Technical Memorandum Jshear
diamonds

To:	Nunavut Water Board
From:	Shear Diamonds Ltd.
Date:	September 15, 2011
Re:	Jericho Diamond Mine, 2AM-JER0410

**Surface Water Management – C4 Diversion
Jericho Diamond Mine, Nunavut**

2AM-JER0410 Renewal Application Technical Meeting June 20-21, 2011

C4 LOCATION AND CATCHMENT AREAS

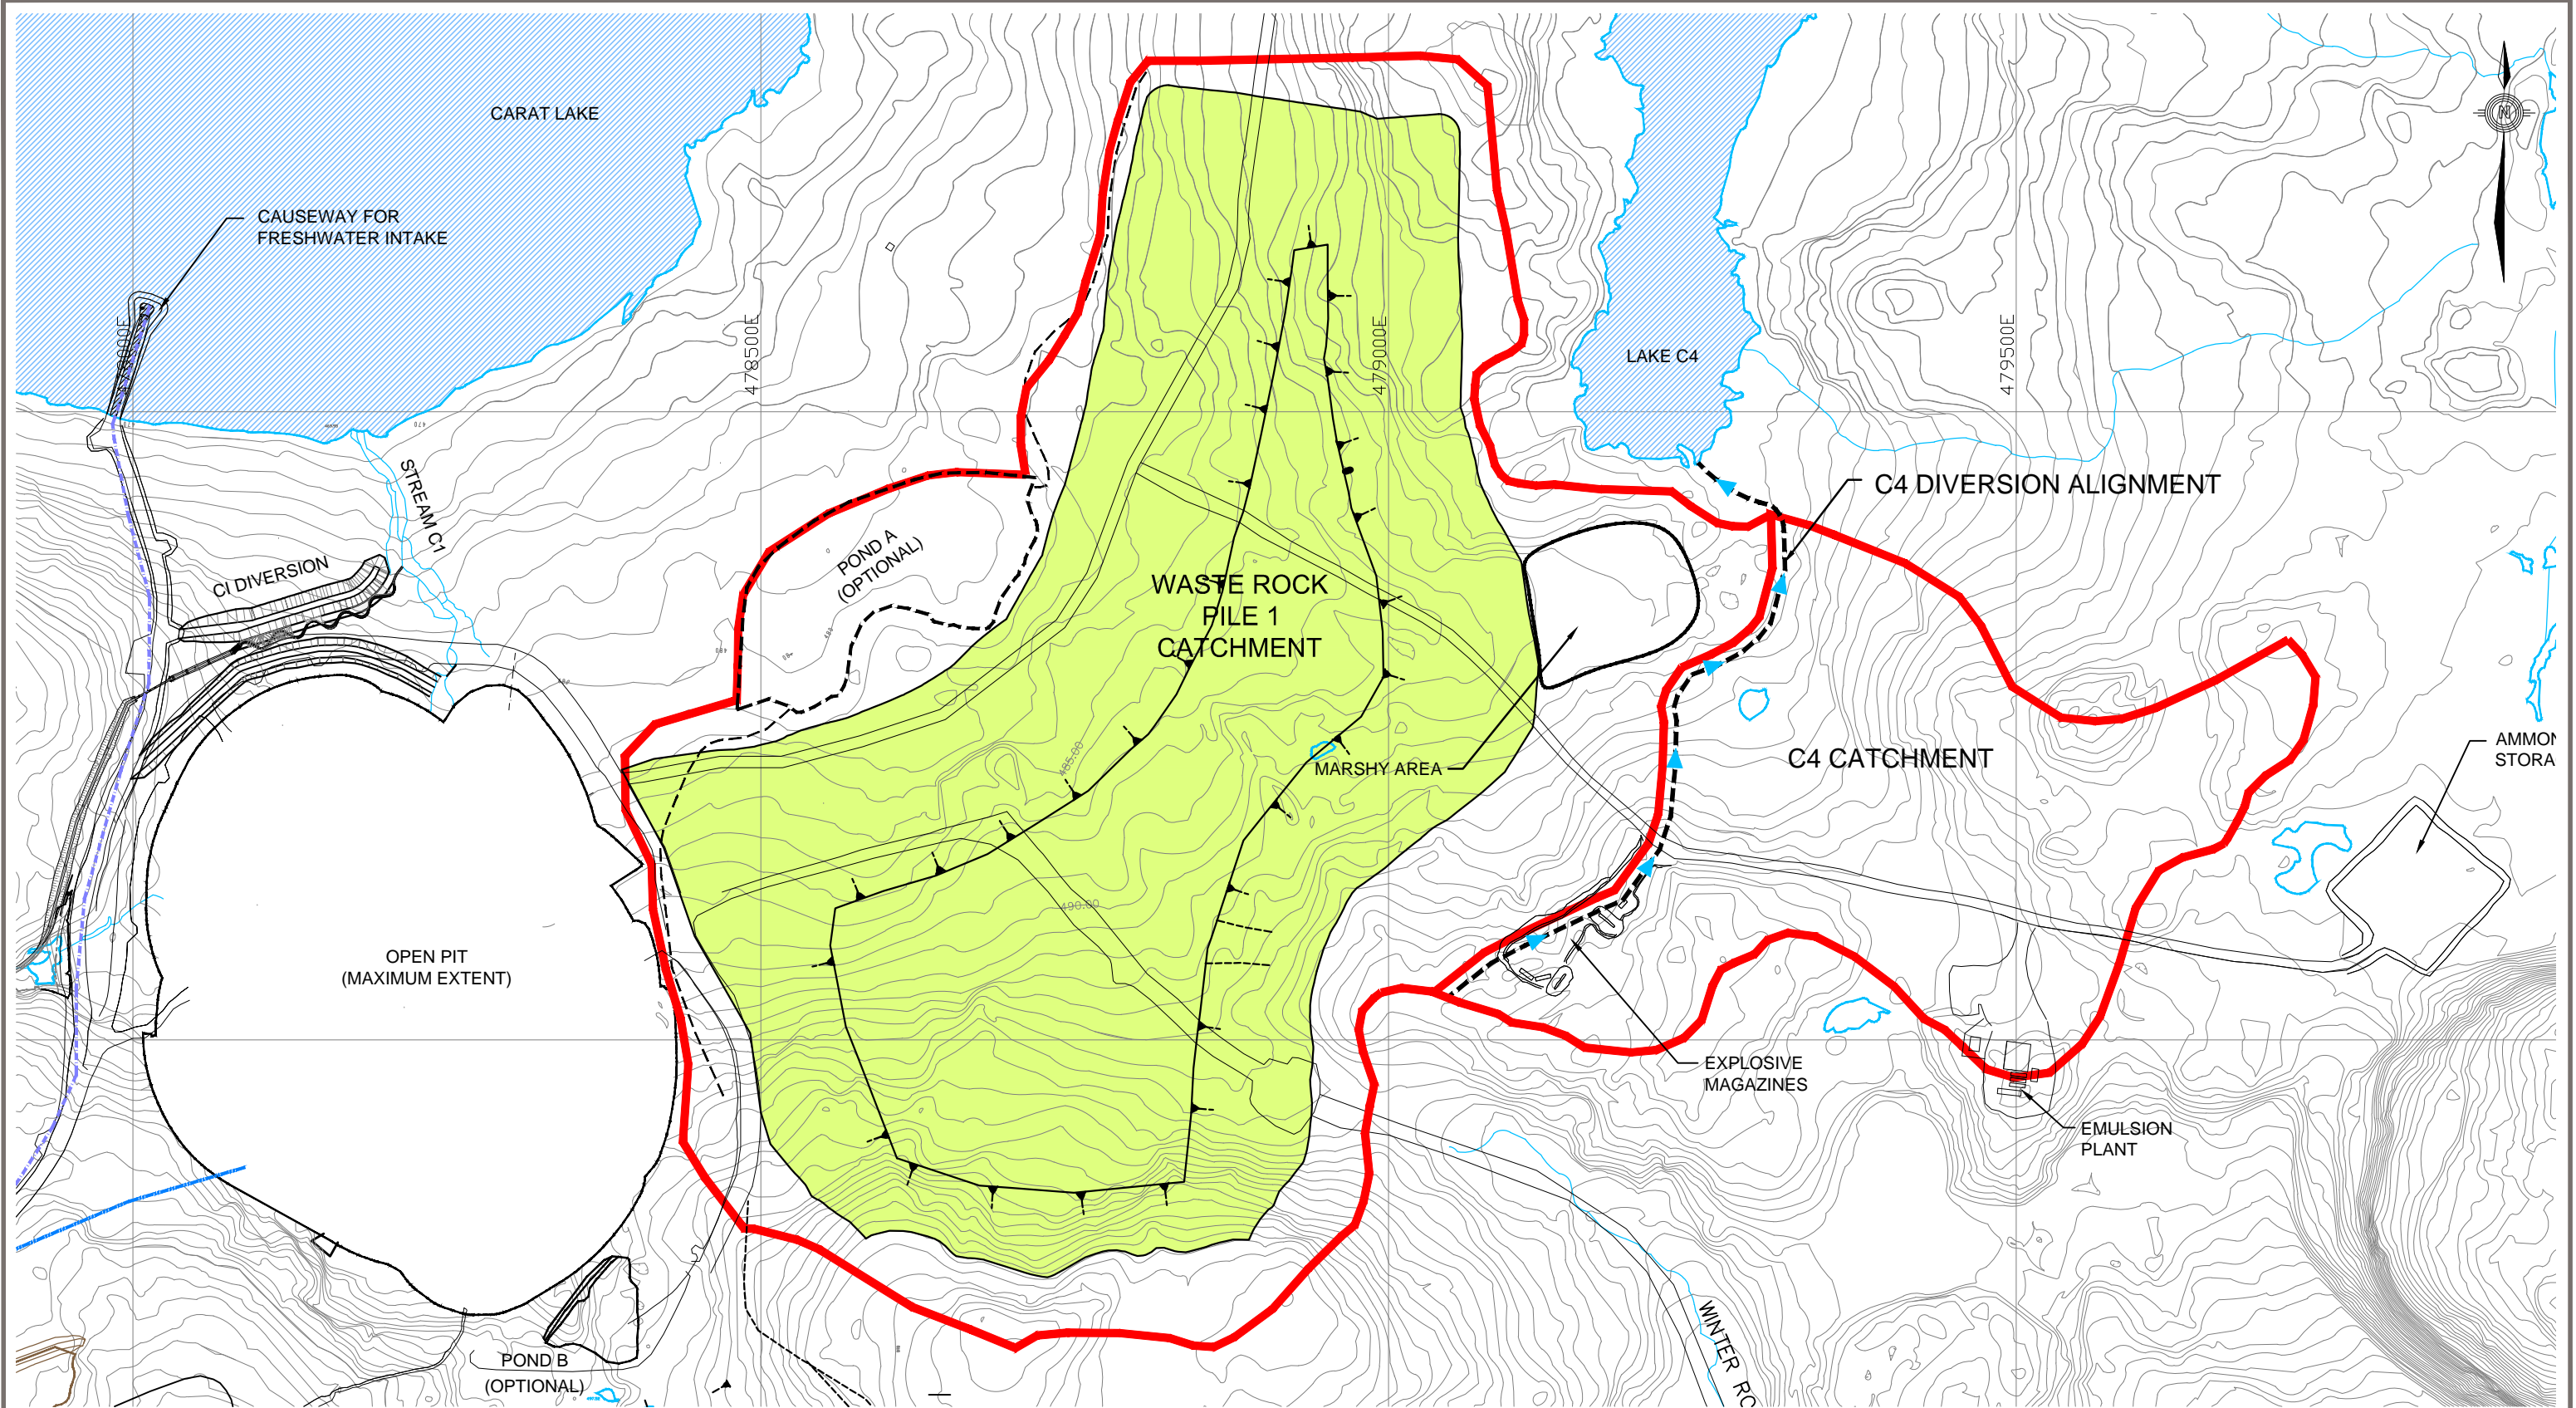
The proposed C4 diversion location is shown in Figure 1. The diversion alignment parallels a proposed access road (not constructed) and discharges to Lake C4. The north portion of the alignment passes along the east side of a low-lying marsh and into a relatively flat area adjacent to Lake C4. The marsh area is lower in elevation than Lake C4 and therefore controls the horizontal diversion alignment. The C4 diversion will divert a maximum of 14.6 ha of runoff that would otherwise report to the marsh area, adjacent to the waste rock pile.

The proposed C4 diversion alignment was inspected in July 2011. The following observations were noted during the inspection:

- The proposed alignment generally runs parallel to the existing contour lines
- Surface conditions generally comprise glacial till, although some open graded boulder fields were present
- Outcropping bedrock was noted near the north end of the alignment, adjacent to the marsh area
- The alignment cannot be shifted closer to the waste rock pile, due to the controlling influence of the marsh. The alignment would likely need to be shifted up gradient, particularly at the south end to develop sufficient runoff diversion grade. This could reduce the catchment area being diverted to C4 by an estimated 3 ha.
- A control structure would likely be required near the marsh area to prevent back flow into the marsh area.

Based on the relatively small diversion area and potential challenges associated with diversion construction, Shear proposes that the C4 diversion be removed from the surface water management plan. Surface water from the C4 catchment area will be allowed to flow through the low marshy area (along the natural drainage path) and will

be managed as part of the waste rock pile runoff. This water will become part of the overall catchment area that encompasses Waste Rock Pile 1 which is 69.7 Ha.
